DRAINAGE REPORT

PRIMROSE POINTE SUBDIVISION
UNIT 3 AMAFCA IMPROVEMENTS
(MAP #C-22)

MAY, 1996

PRIMROSE POINTE UNIT-4
PRELIMINARY GRADING AND
DRAINAGE PLAN WEST

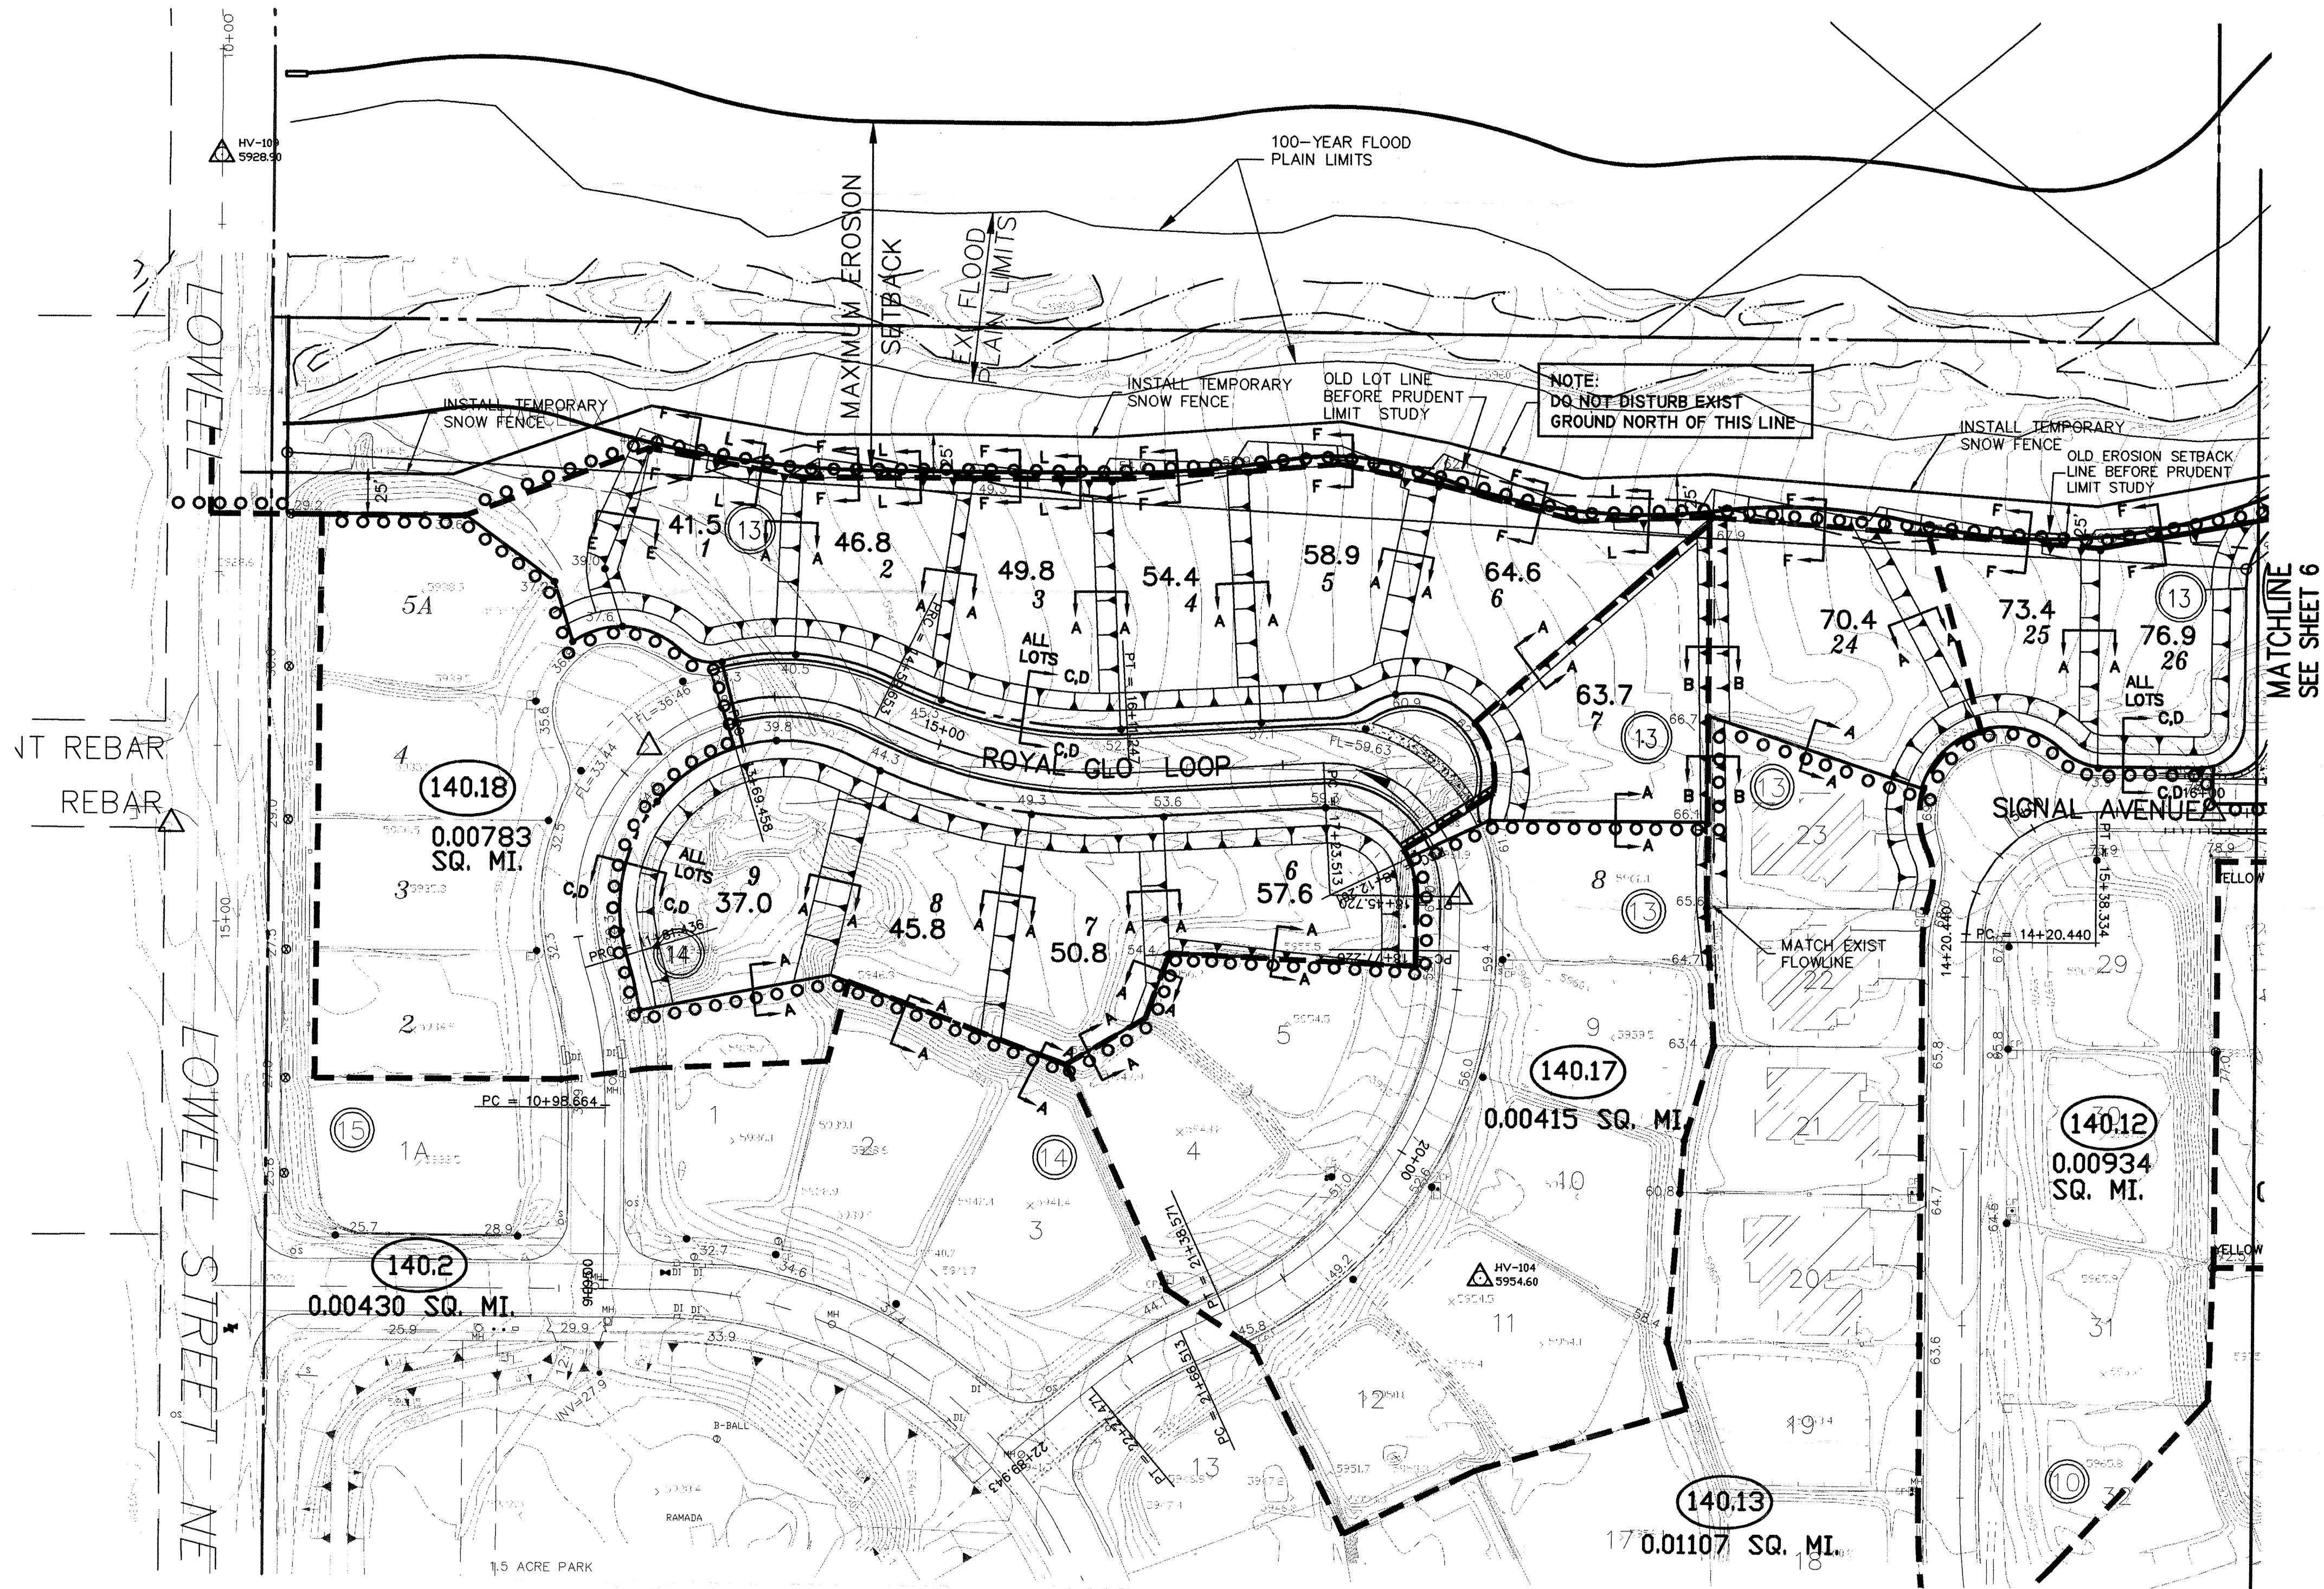
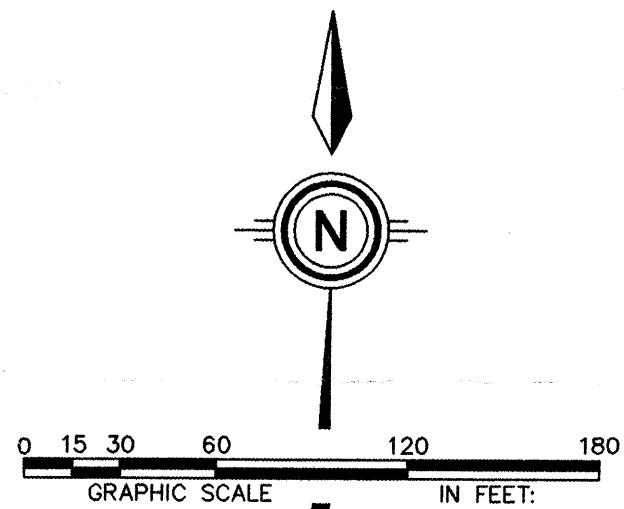
1. The plan must show the limits of the erosion setback (ESB) that we previously approved. It is unclear from this plan whether the proposed Lots encroach in the ESB. The plan must also show the limits of the existing FEMA floodplain and the AMAFCA easement.
2. Several of the details on Sheet 3 use 1:1 side slopes. I doubt that the soils can maintain 1:1 side slopes without some sort of treatment to keep them stable. Perhaps retaining walls should be considered.

Based on the information provided in the submittals of February 1, 1999 and March 25, 1999, the above referenced plan is approved for Preliminary Plat action.

The Final Plat must provide the floodplain easement as shown on this approved plan.

PLATE 2- LA CUEVA ARROYO PLAN & PROFILE

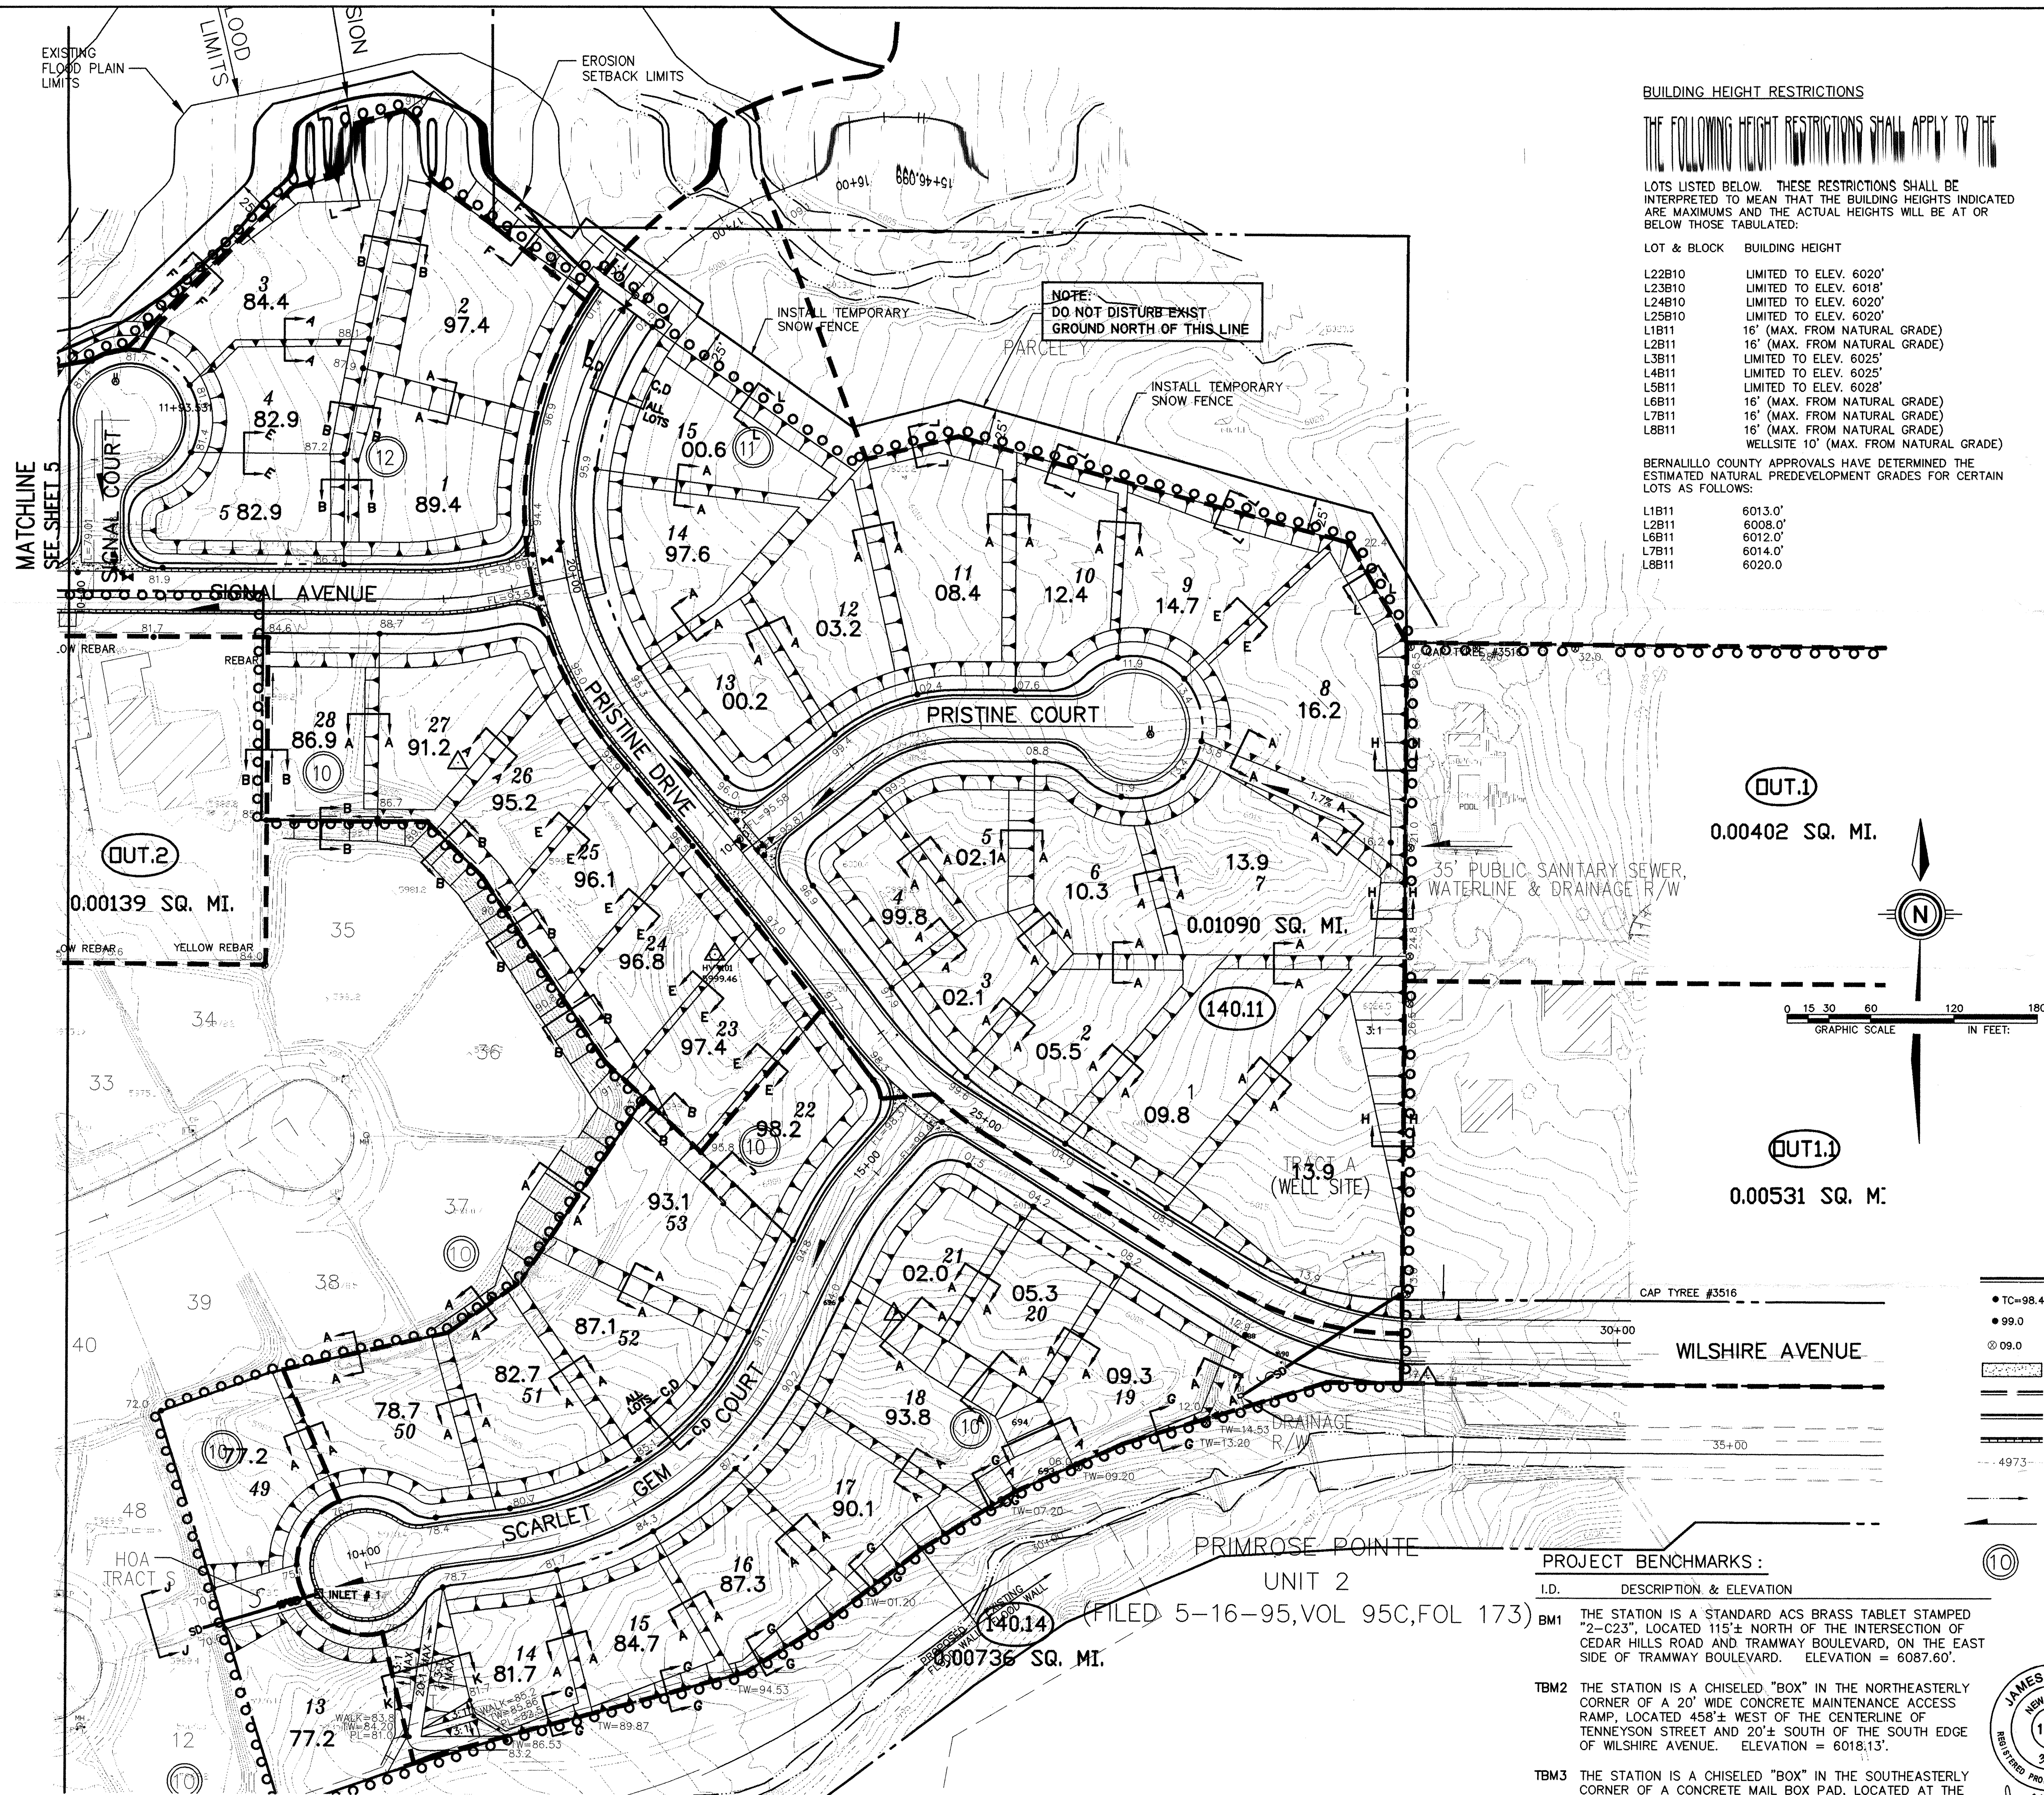
Is this ESB what
was previously
approved?
Are these ESB limits on
the plans?
